PEER REVIEW REPORT

Lower East Coast subRegional Groundwater Flow Model and Draft Model Documentation

South Florida Water Management District

June 7, 2006

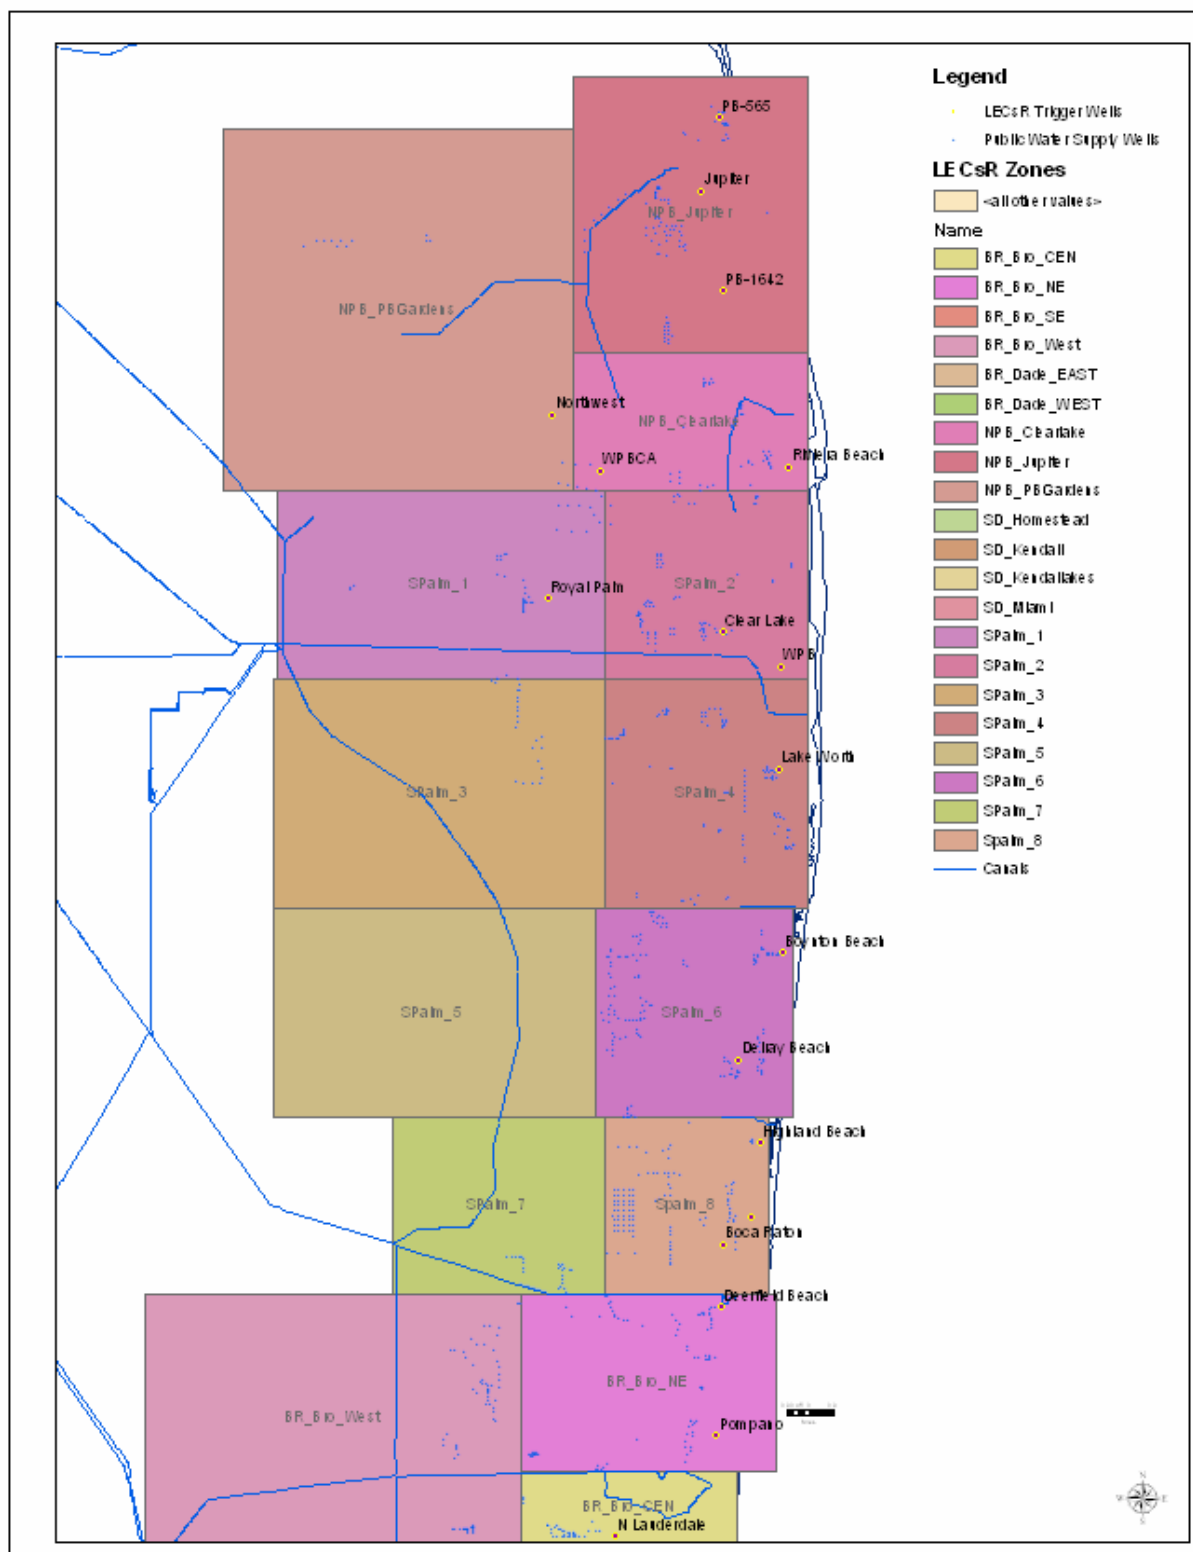
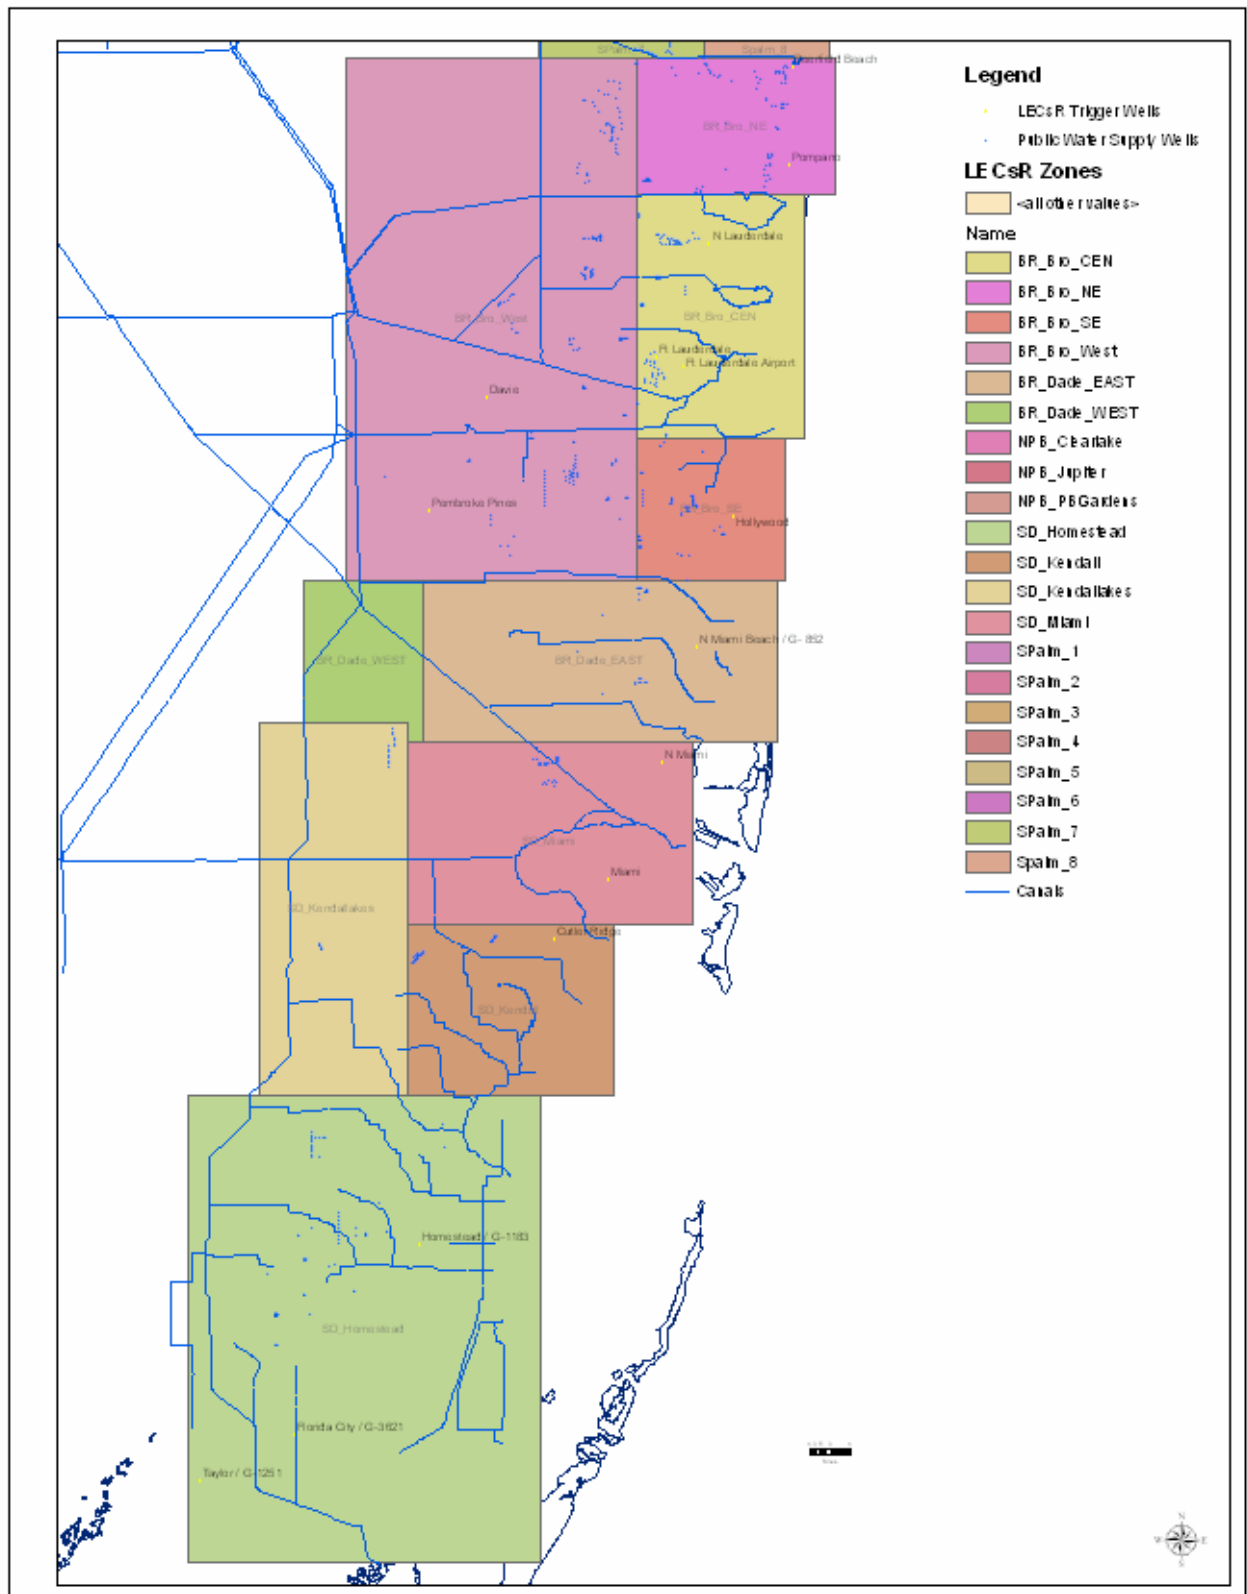
Comment / Question 57: How are reduced pumping rates determined when the Trigger Package is invoked? Does the model iterate to find the maximum pumping rate that just eliminates the violation? In Trigger package, please explain why, if a violation occurs, the previous stress period's pumpage used instead of some new converged value? How are individual well pumping rates determined when the Trigger Package is invoked due to multiple production wells causing the violation?

Response 57: The Trigger Package is not used in the calibrated model; it is used only for predictive applications. The trigger module works according to zones, which are user-specified rectangles. In each zone there are trigger cells. If the head (or drawdown) in a trigger cell at the end of a stress period is lower than a standard, which is user-specified, the program looks for each well in the zone and reduces the pumpage for the next stress period by a fraction specified in the input data. No, the model does not iterate to find the maximum pumping rate therefore the previous pumpage value must be used to calculate the reduction in pumpage. The individual well pumping rates are determined by the zones and pre-specified trigger levels as discussed above and in Chapter 3, pages 79-80. The following figure shows the trigger zones and the trigger wells.

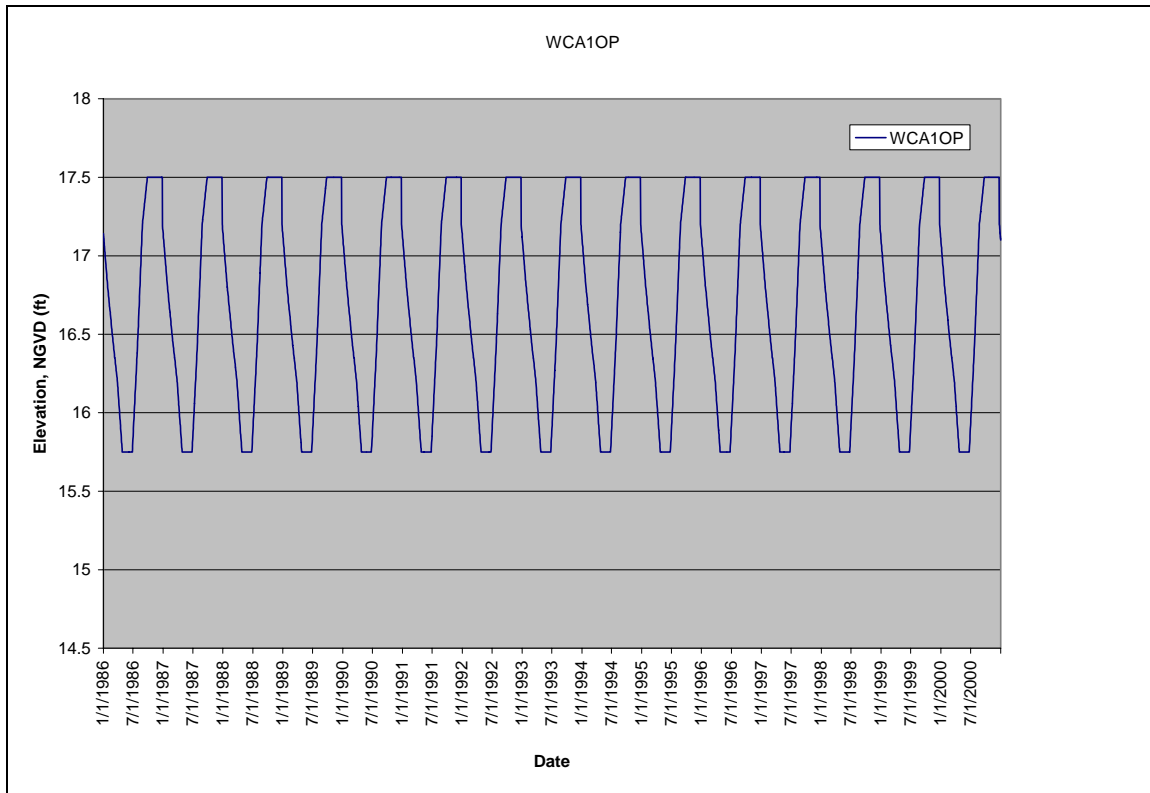
Comment / Question 104: Does the RDF package use historical operational rules in the calibration? Do they exist for the period of record? Haven't the changed? How is this accounted for?

Response 104: The RDF Package uses operational schedules which must be implemented in the model as daily stages. This package has the ability to change the schedule each stress period. Therefore, if the schedule changes halfway through the calibration period, the changes can be implemented. An example is presented below for the RDF Package; the stages are provided in the UGEN Package.

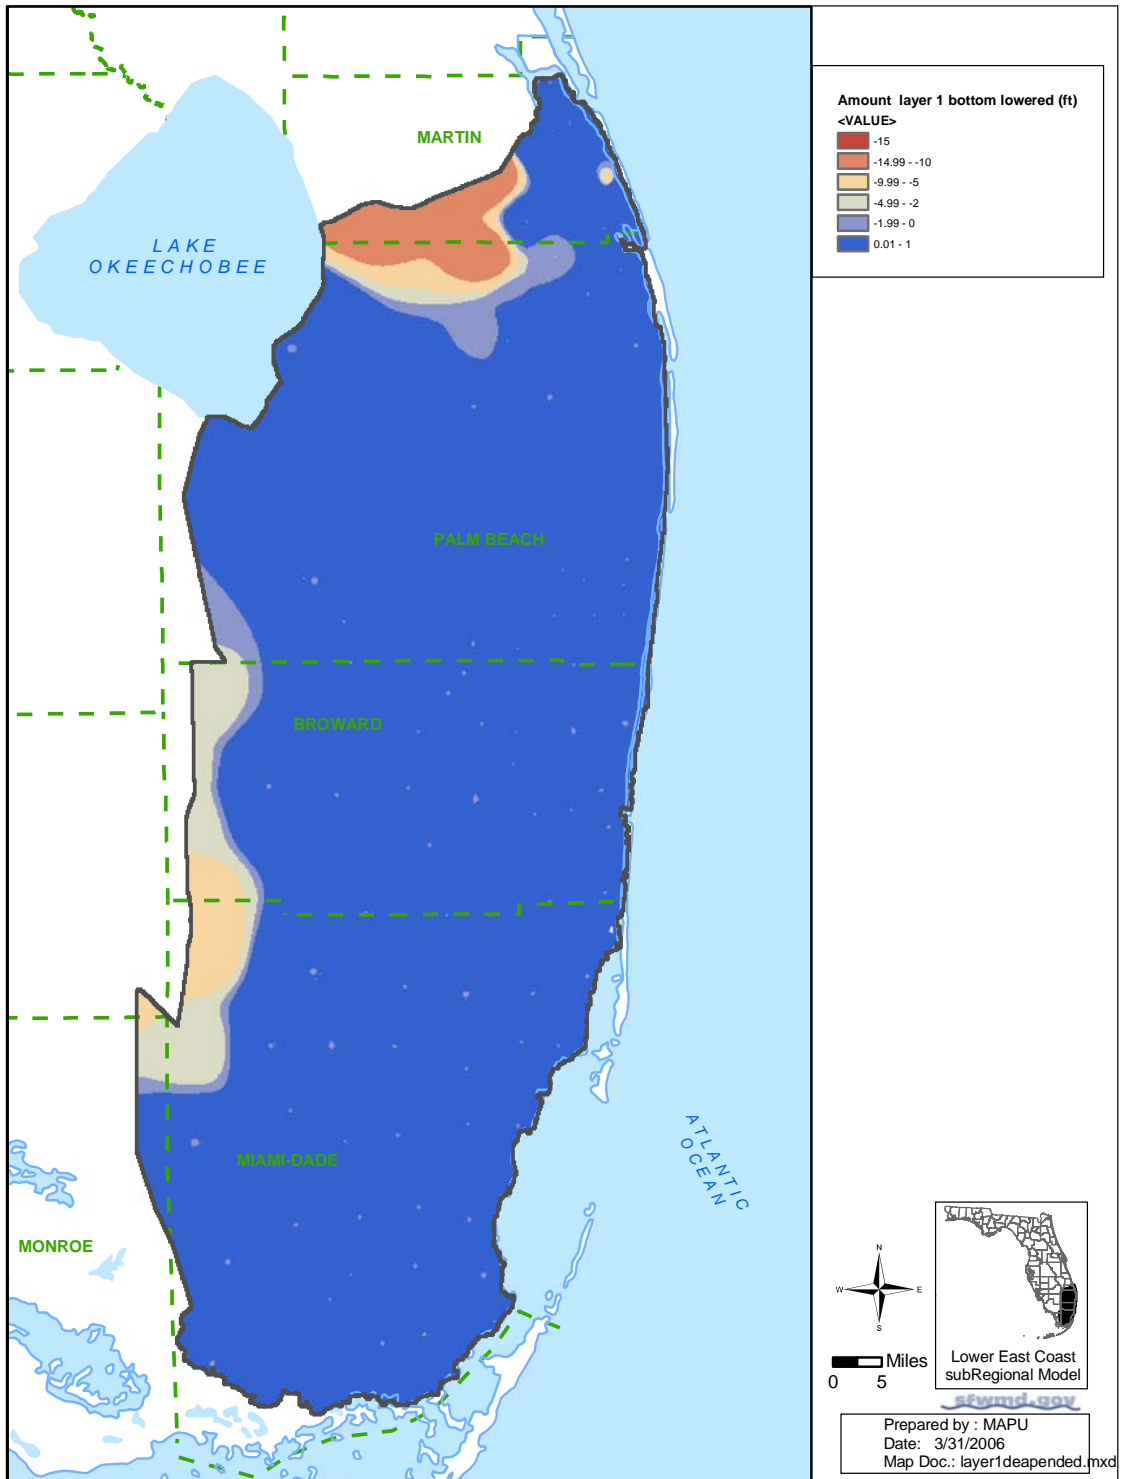
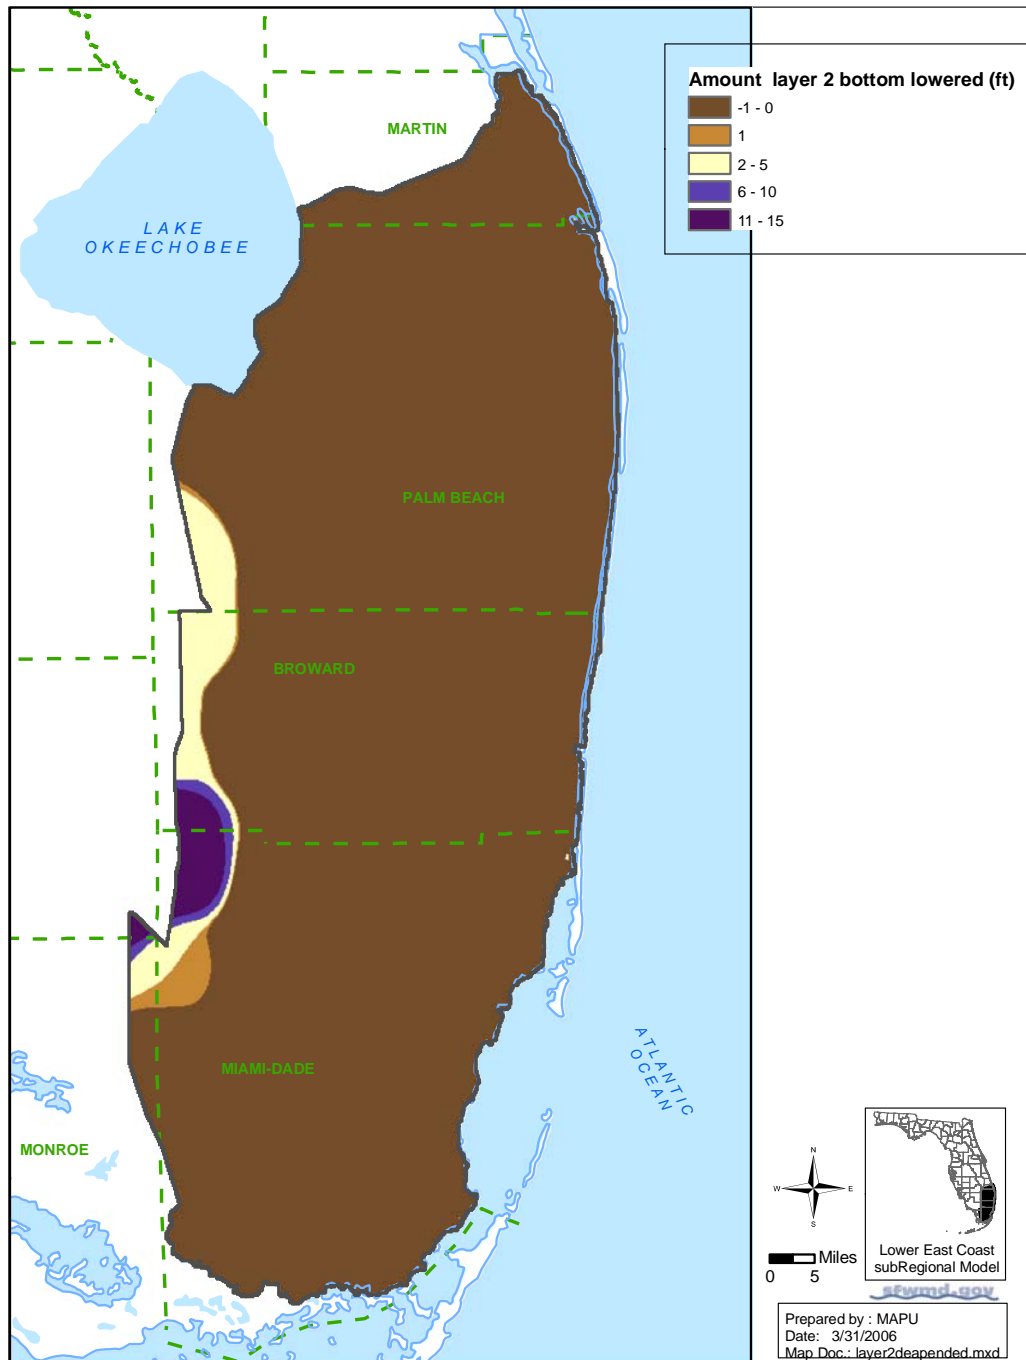
Comment / Question 118: Could you give us an indication about how large an area required adjustment (# of cells, a graphic, etc)?

Response 118: Figures are provided below.

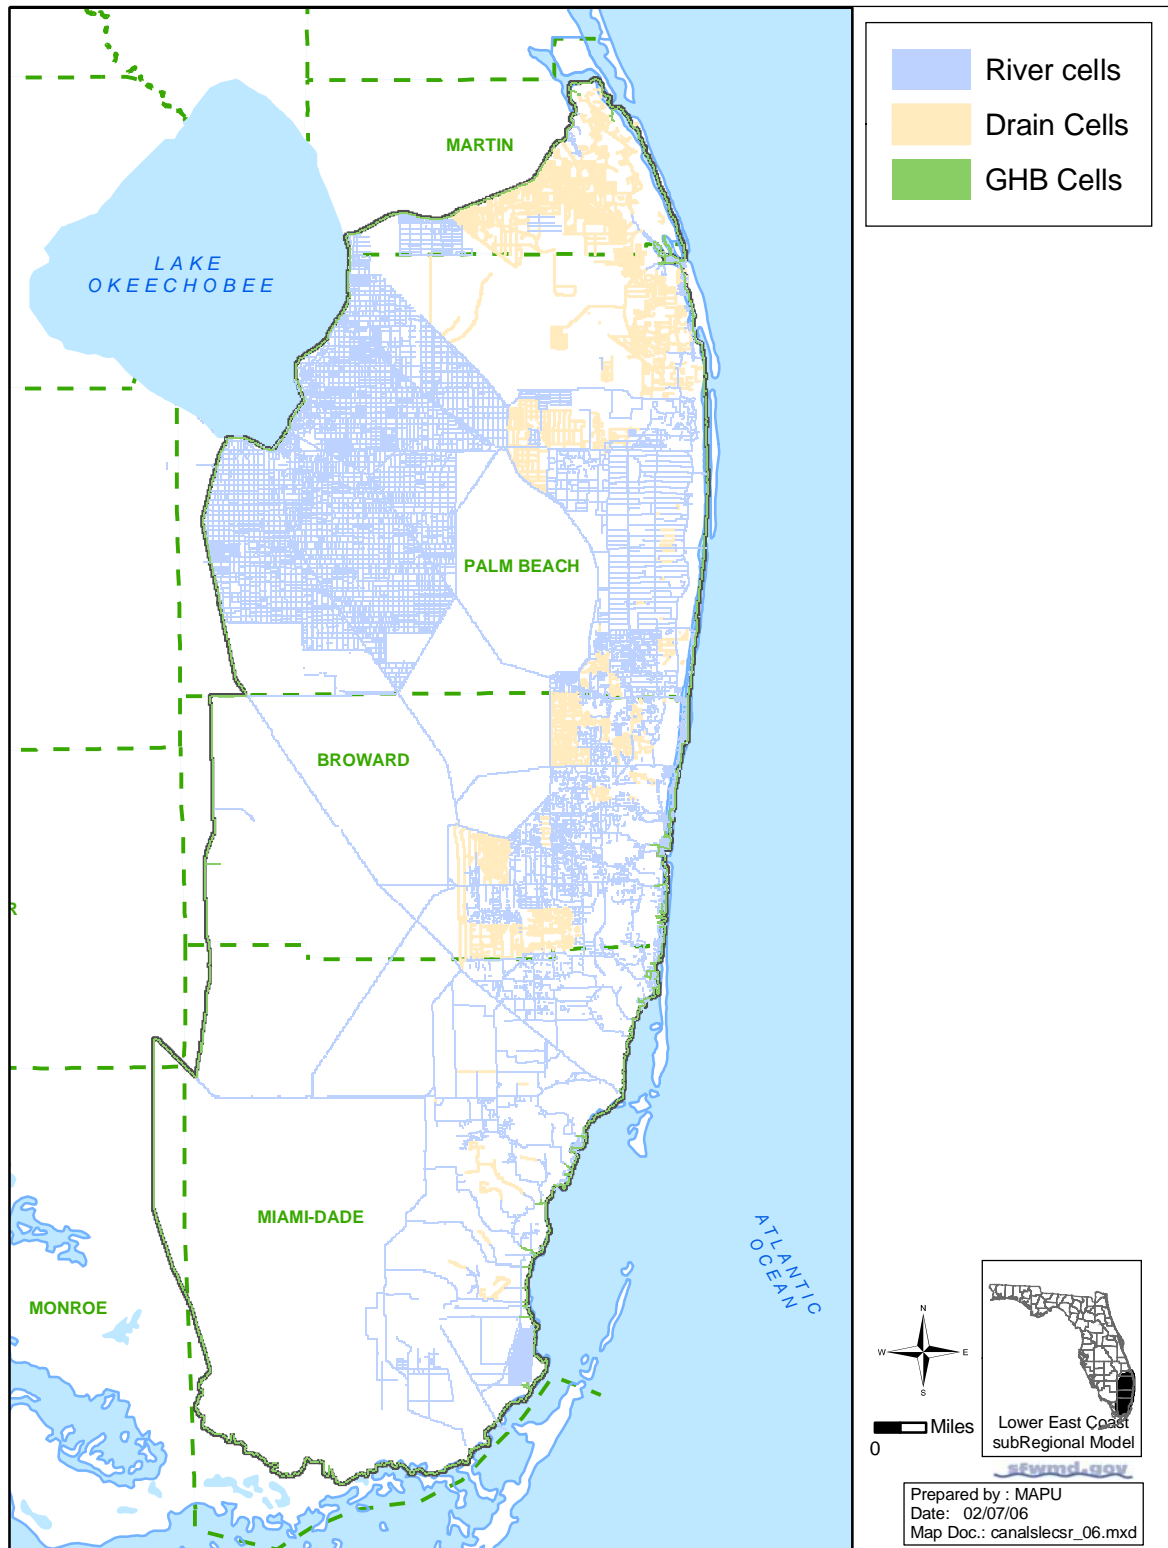
Comment / Question 196: Please show the location of all rivers and drain cells and groups of such cells for which parameters are common in a figure. If shown elsewhere in the report, it should again be cited here.

Response 196: Figures have been placed in the document.
